**BEFORE THE BOARD OF PATENT APPEALS  
AND INTERFERENCES**

Application Number: 10/674,852  
Filing Date: September 29, 2003  
Appellant(s): ASHFIELD, LEA ANTONY

**EXAMINER'S ANSWER**

Diagram 1. Labeled elements of the present limitations.

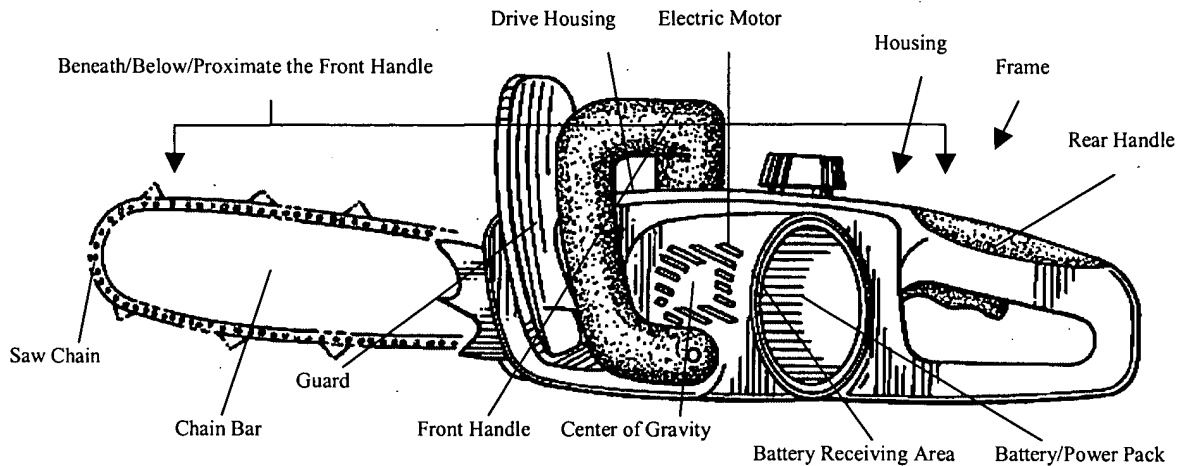
Claims 1, 4-6, 10, 14-16 and 20 are rejected under 35 U.S.C. 102(b) as being anticipated by Juratovac et al (D408,246), hereafter Juratovac. Juratovac discloses a battery operated chain saw with all of the elements described in the claim limitations. The figures clearly show a removable battery coupled to the motor in the figures. The battery and power pack is the oval shaped member shown in the figures. The electric motor lies within the vented motor housing shown in the figures adjacent to the oval-shaped battery. The center of gravity of Juratovac is located at least partially beneath the front handle as shown in the figures. The battery receiving area is on the back of the motor housing juxtaposed the oval-shaped battery and the motor housing as shown in the figures. The front-to-rear centerline is collinear with the rear handle and the battery is entirely spaced from the front-to-rear centerline as shown in figure 3. Juratovac inherently has an electrical coupling on the battery/power pack because every battery/power pack needs an electrical coupling in order to supply its power to a motor. Note the elements of the present limitations labeled below in Diagram 1.

In regards to claim 20, the power pack is located at least partially in front of the front handle when the front-to-rear centerline is in an inclined or vertical position.

In regards to claim 10, the configuration of the chain saw in Juratovac is the means that locates the front-to-rear chain saw center-of-gravity proximate the front handle.

Appellant asserts that the member indicated as “electric motor” in Diagram 1 above is not an electric motor because Juratovac is a design patent and does not have an enabling disclosure for an electric motor. However, one of ordinary skill in the art recognizes that motors must be kept in vented housings in order to exhaust heated air created by the heat in the motor. As shown in figures 1 and 4 of Juratovac, there is only one element that has venting, therefore, the vented housing contains the electric motor.

Appellant asserts that the oval shaped member indicated as “Battery/Power Pack” in Diagram 1 above is not a battery/power pack because Juratovac is a design patent and does not have an enabling disclosure for a Battery/Power Pack. However, the title of the Juratovac reference is “Housing for a *Battery* Operated Chainsaw,” which is a disclosure that Juratovac has a battery. One of ordinary skill in the art would have interpreted the oval-shaped member shown in the figures, and labeled in Diagram 1 above, as a Battery/Power Pack because the size of the oval-shaped member is proportional to the size of the battery needed to operate other battery-powered tools, such as the battery/power pack 30 in the Anthony, III reference.

One of ordinary skill in the art would have known that the center-of-gravity lies in a plane that is below the front handle because as shown in Diagram 1 above, the front handle is the highest (vertically) element of the Juratovac chain saw save for a small portion of the guard. If the center-of-gravity were not located at least partially beneath the front handle, then the front handle would have to significantly outweigh the motor, the battery, the housing, the chain bar and the saw chain, which is impossible.

Appellant asserts that the battery and the center-of-gravity are not located at a position proximate to the front handle. However, using appellant’s own definition, which was taken from *Merriam-Webster’s Collegiate Dictionary*, of “very near: close”, Juratovac discloses that the battery and the center-of-gravity are located very near and close to the front handle. The compact design of the chain saw is such that all of the elements are very near or close to one another. Moreover, the battery and the center-of-gravity are closer to the front handle than other elements of the chain saw, i.e., the front tip of the chain bar.
